PLANS OF PROPOSED IMPROVEMENTS ON THE
SECONDARY ROAD SYSTEM
BOONE COUNTY
BRIDGE & APPROACHES - PPCB
ON 120th ST OVER SQUAW CREEK

TOTAL SHEETS	38
PROJECT NUMBER	IBRC-C008(39)--8E-08
R.O.W. PROJECT NUMBER	
PROJECT IDENTIFICATION NUMBER

LISTING OF PROJECT REVISIONS

REVISION SHEET

SITUATION PLAN

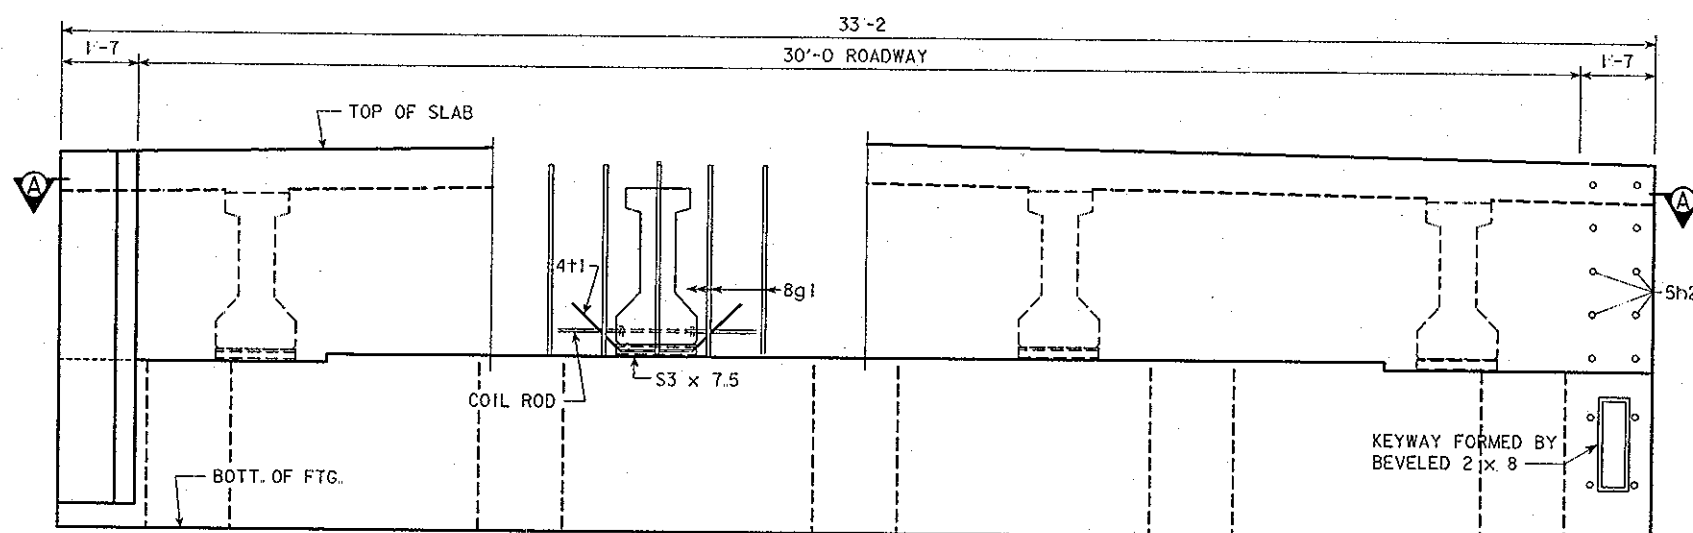
REVISED 11-06-06: CHANGED GRADE ON BRIDGE.

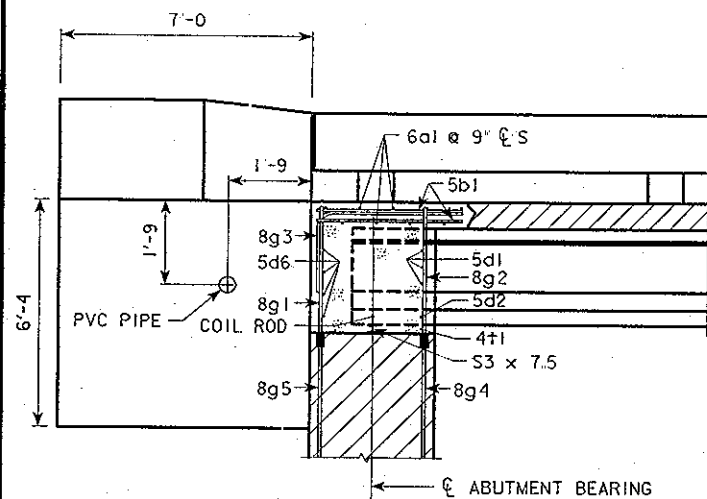
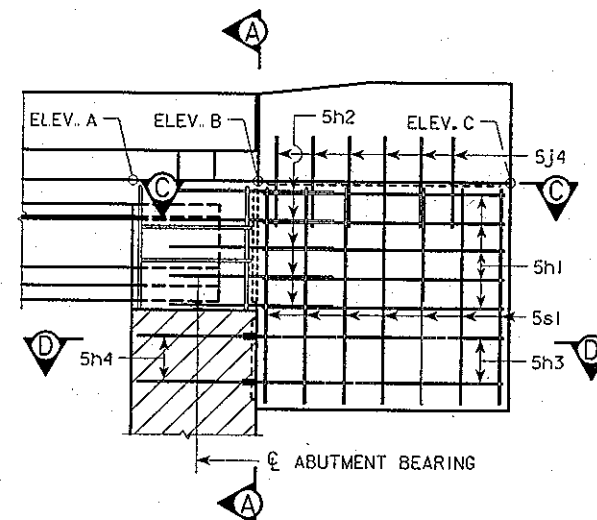
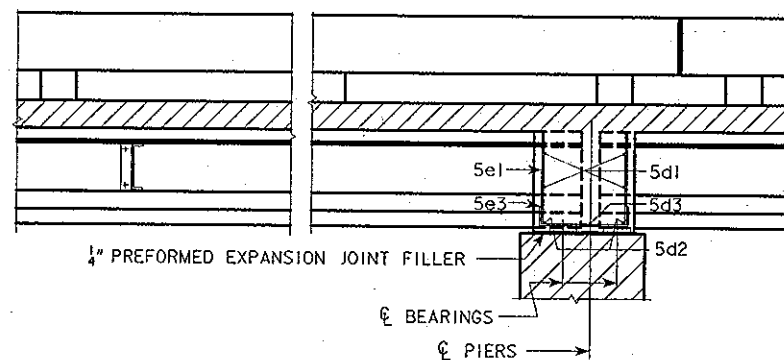
REVISED 11-06-06: BEAM SPACING DIMENSIONS CORRECTED AND KEYWAY DIMENSIONS ADDED.

PART SECTION AT MID SPAN

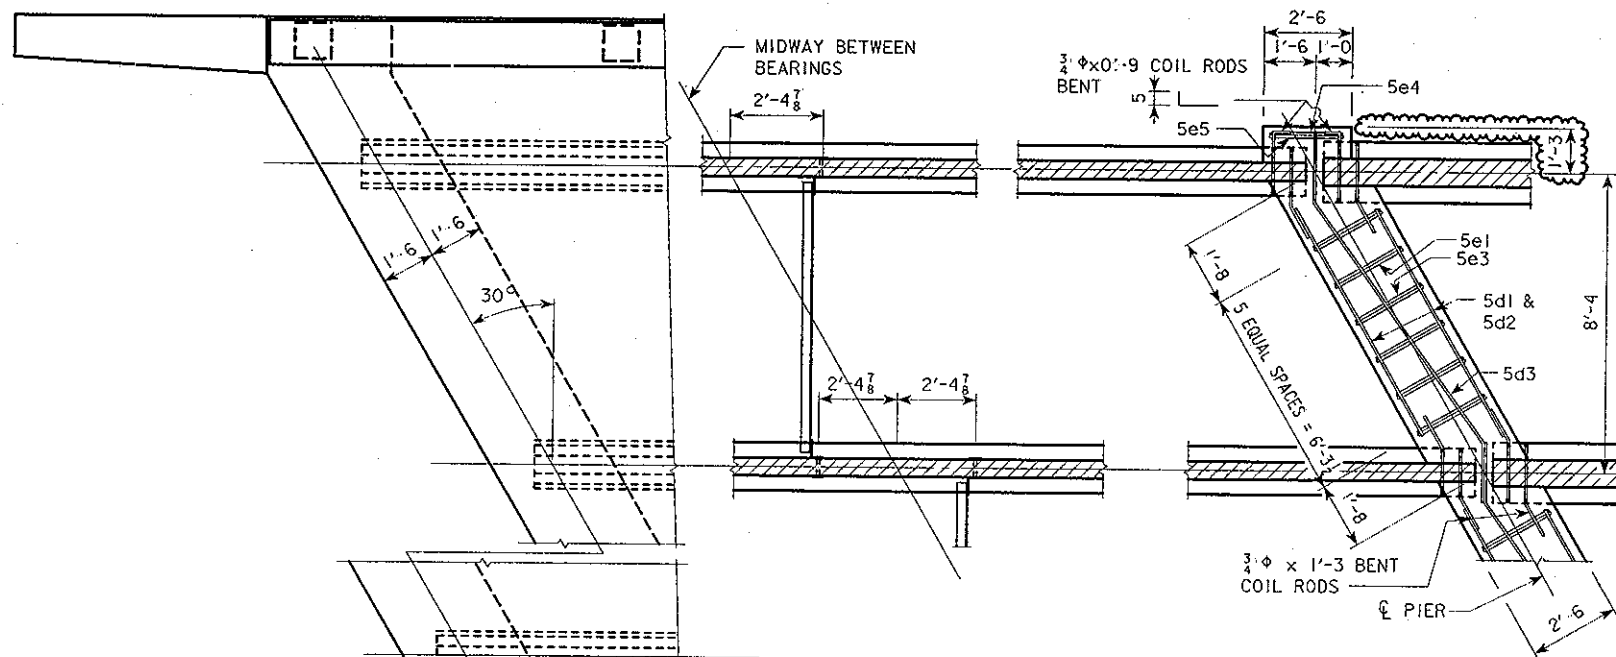
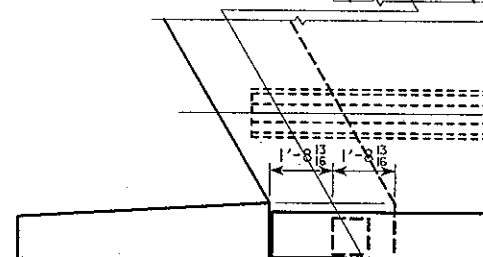
REVISED 11-06-06: ADDED DIAPHRAGM END DIMENSION AND REVISED PREFORM DETAIL.

TOP OF SLAB ELEVATIONS

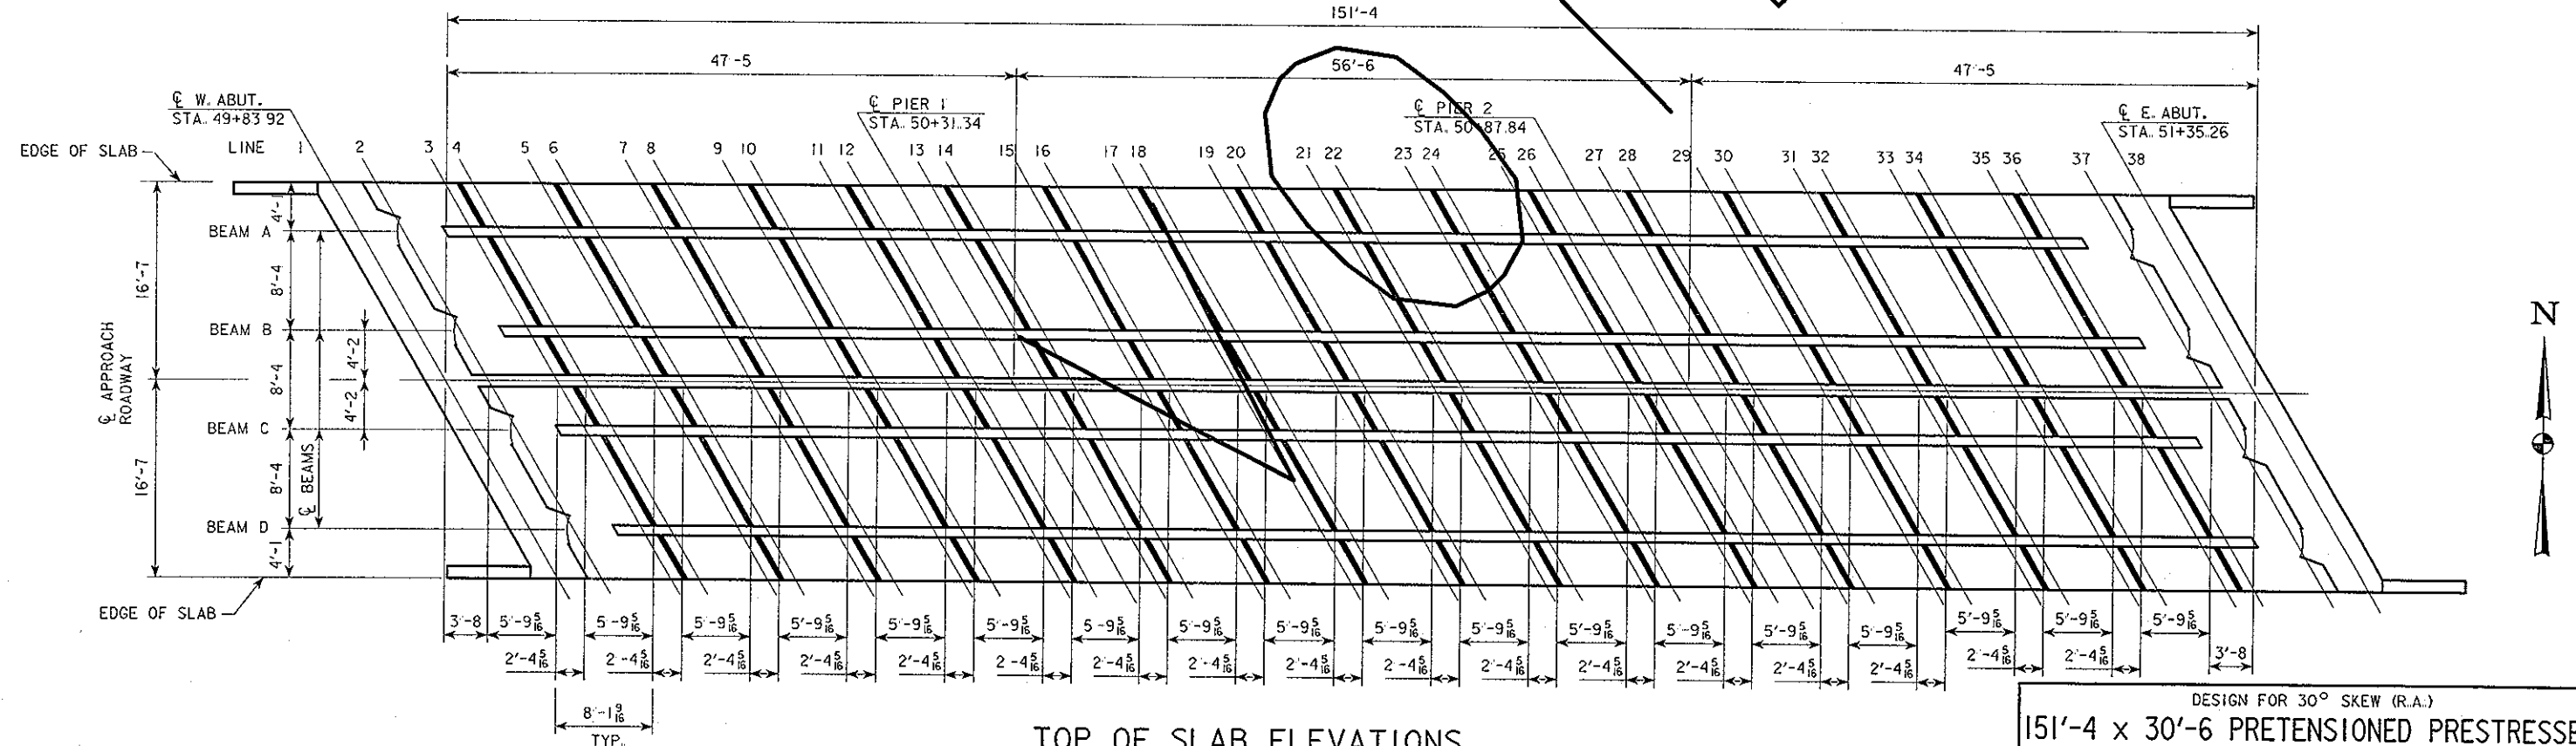
REVISED 11-06-06: THIS SHEET DELETED.

BENT BAR DETAILS

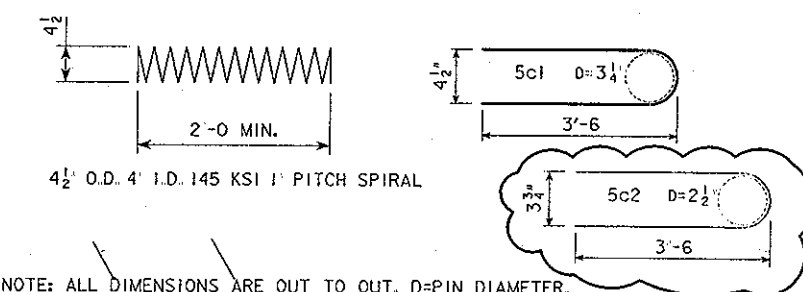
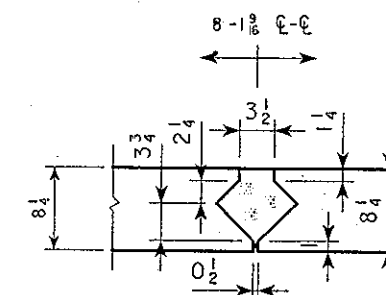
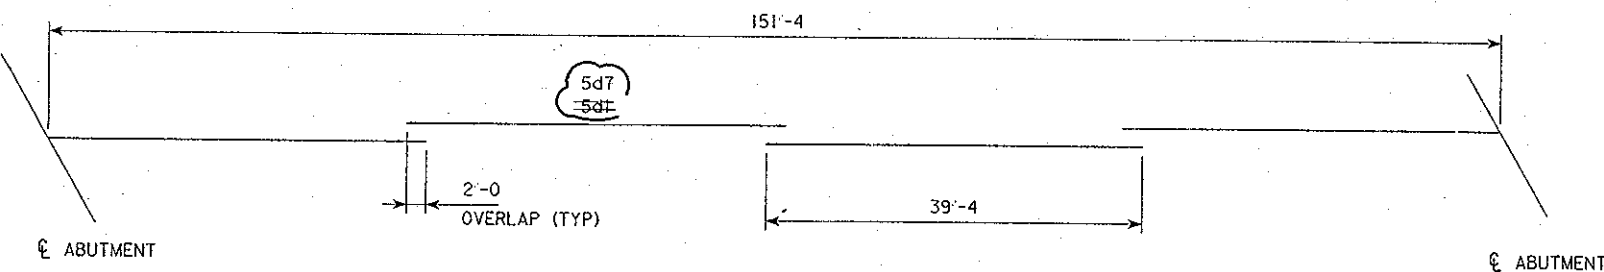
REVISED 11-06-06: BAR BEND DIAMETER CHANGED FOR CLOSURE POUR HOOKS TO ELIMINATE CONFLICT WITH THE TOP MAT WELDED WIRE REINFORCEMENT.

ELEVATION OF RAIL

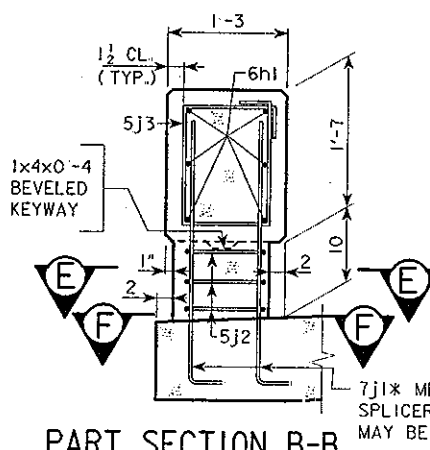
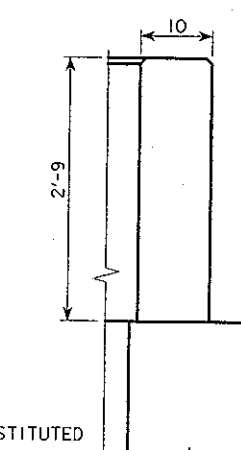
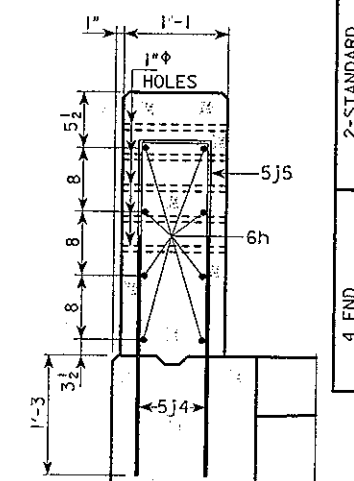
REVISED 11-06-06: CRACK CONTROL JOINTS ADDED.
